DEVELOPMENT REVIEW

Project description Applicant is proposing two commercial buildings totaling 88,748 sf of office / flex space and a 33,190 sf building for RV storage with associated site improvements.

**Re: 2564 S. Kings Highway – Development & Design Review
TRC Response to Comments
TRC Project # 20-07000002**

On behalf of our client, please find the attached response to comments received on March 18, 2021 for a project known as Walsh Kings Highway. Each comment is identified below followed by a response in ***bold italics***.

2324-232-0000-000-4
COMMERCIAL SOUTH LLC
2496 S KINGS HWY

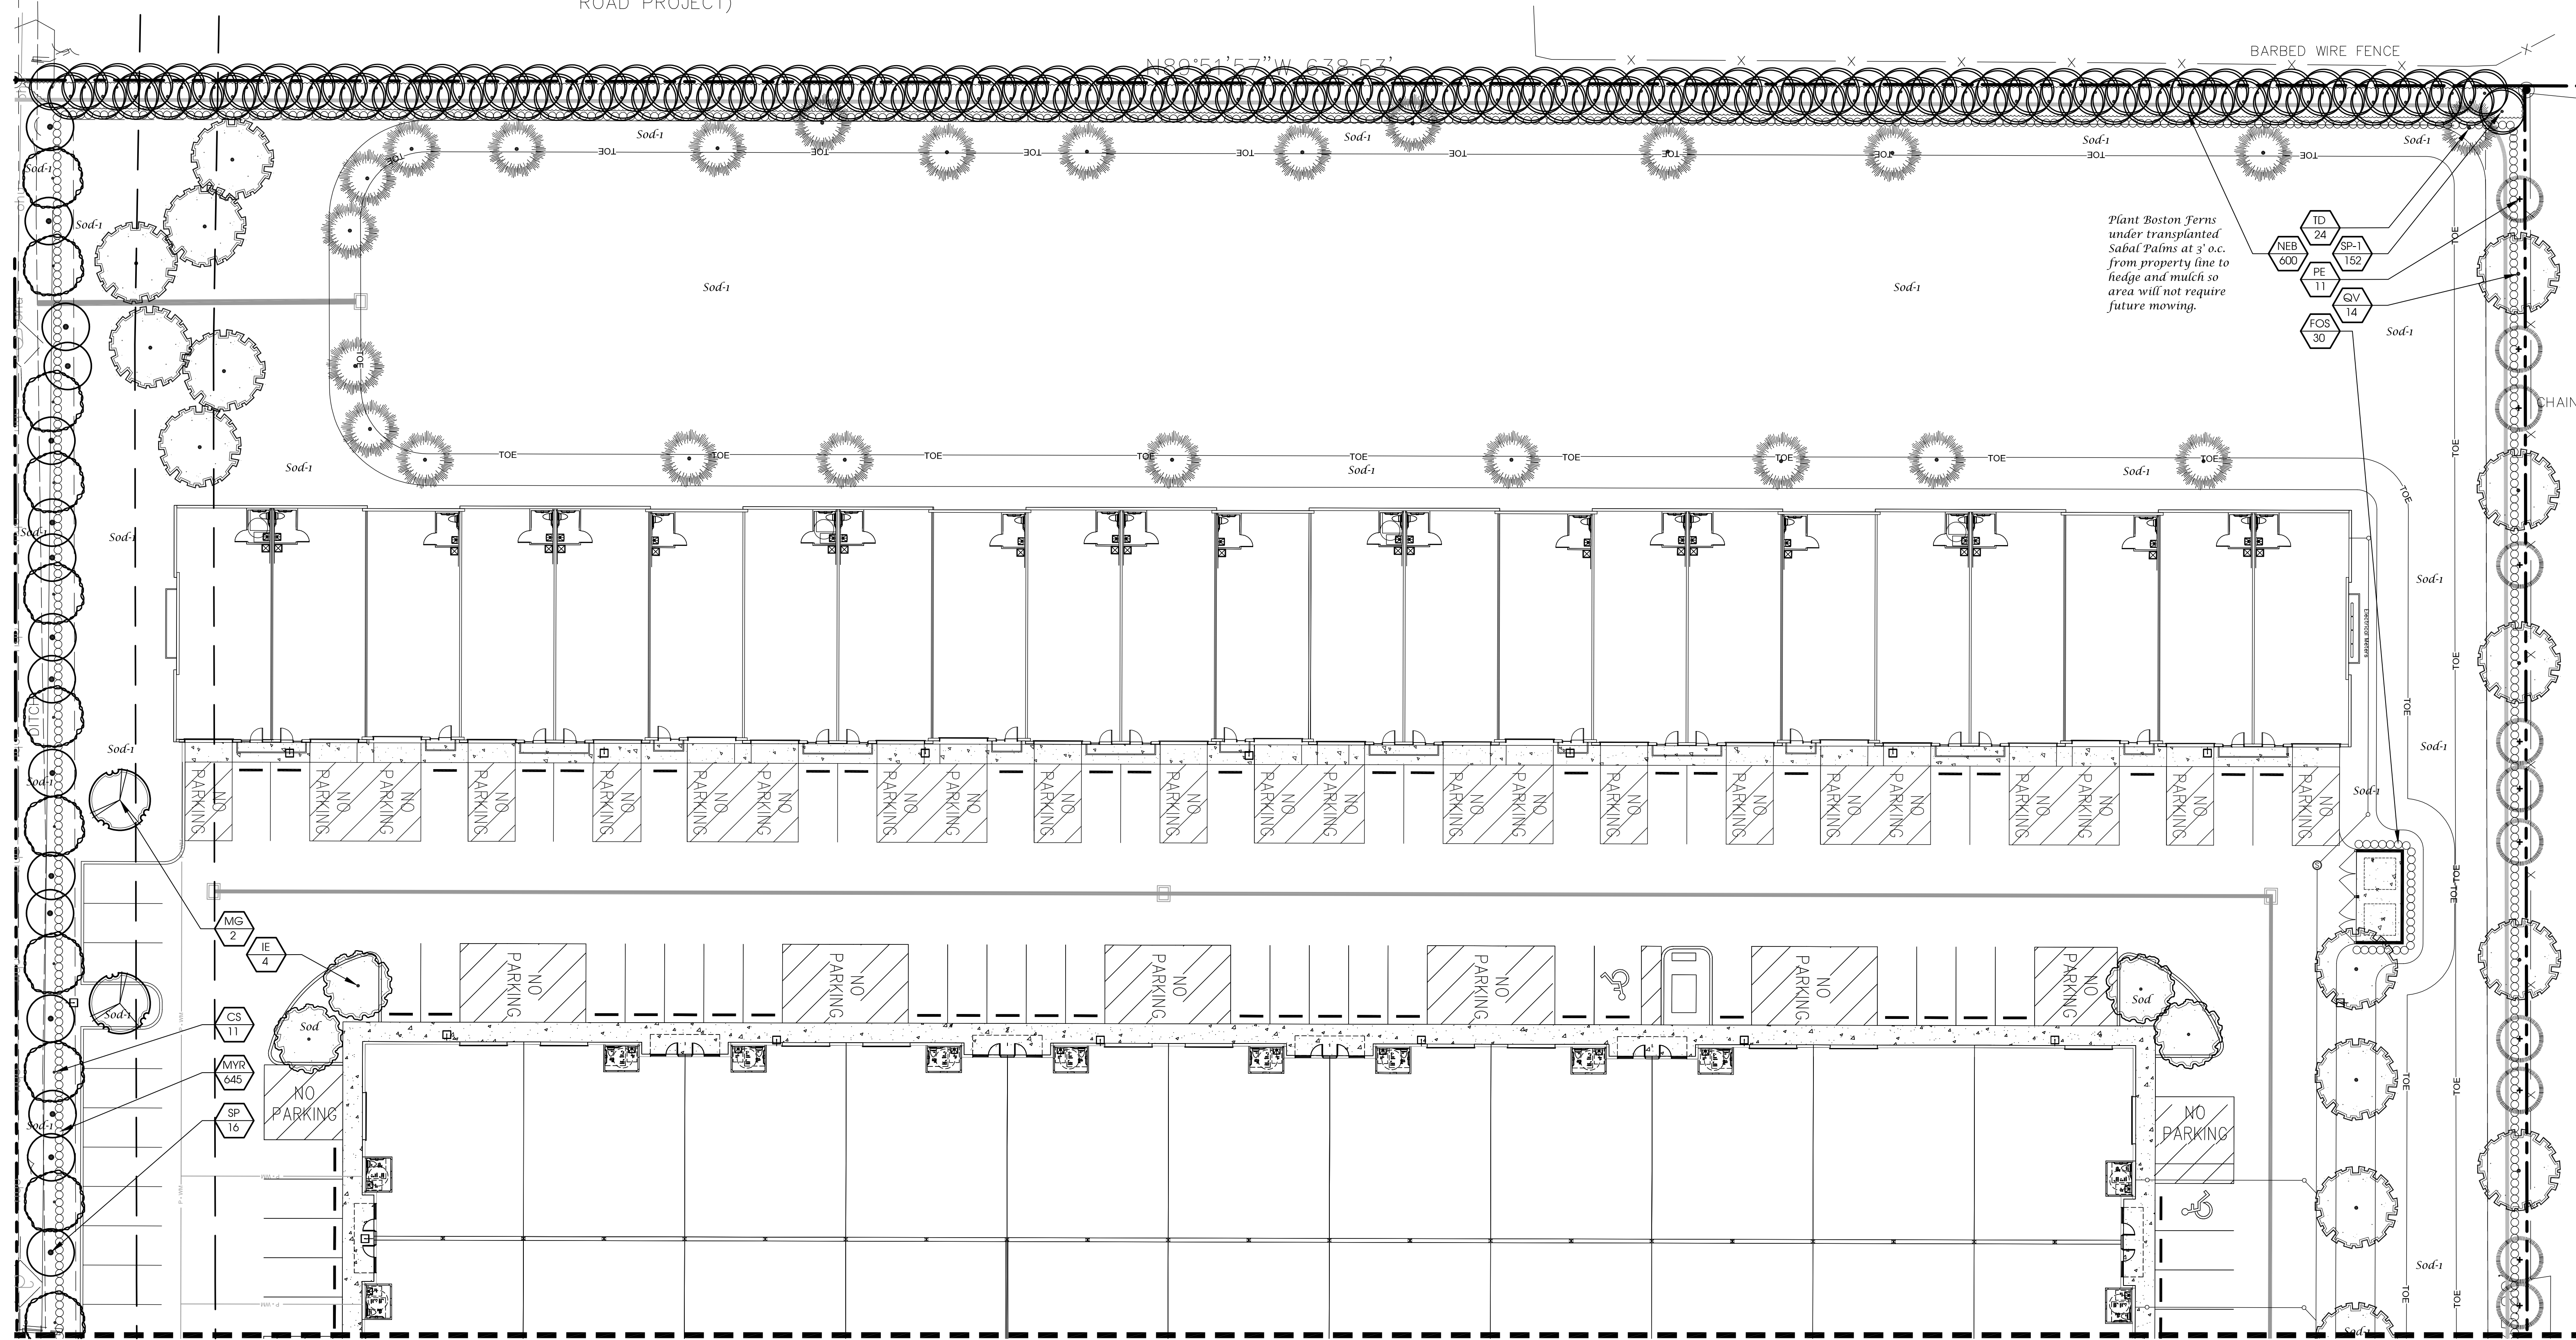
8. A tree mitigation plan was not found with the landscape plan, provide this plan to show all trees that will need to be mitigated for based on the site plan. Also calculate the trees that will either be saved, relocated, or planted and come up with the required mitigation calculation if mitigation will be required. Overall, the provided landscape plan appears to be consistent with code.

9. Provide some landscape design elements to the detention area.

RESPONSE: *Please find the attached arborist report that calculates the required tree mitigation at \$ 62,998.57.*

RESPONSE: *Please see revised site plan and landscape plans. The addition of*

buffering by the detention area to screen it from view has been added.

Figure 3
Driveway Volumes
 Walsh

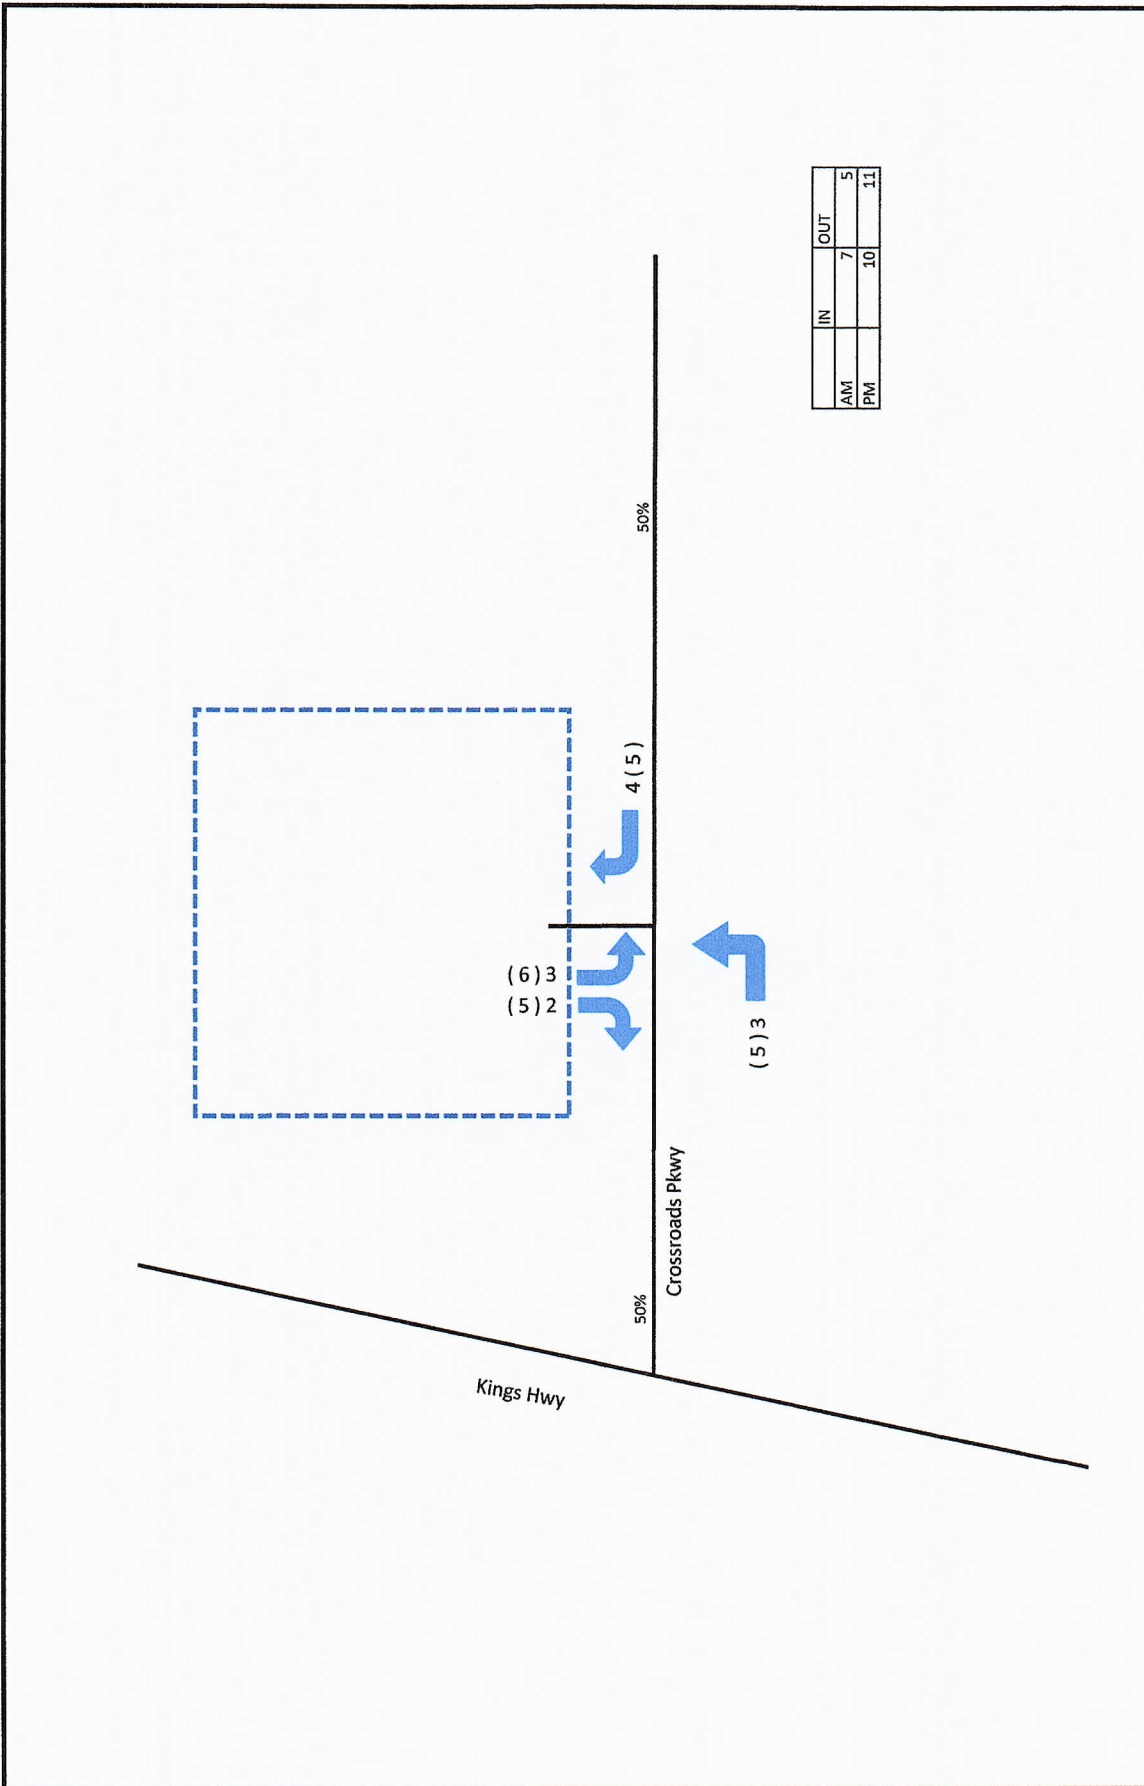
1. Please provide an intersection analysis for the proposed full access driveway on Crossroads Parkway.

2. Please provide a turn lane analysis at the proposed full access driveway to justify the recommendation of no ingress turn lanes.

An intersection analysis for the proposed driveway on Crossroads Parkway has been added to Appendix D.

A turn lane analysis for the proposed driveway on Crossroads Parkway has been added to Appendix D.
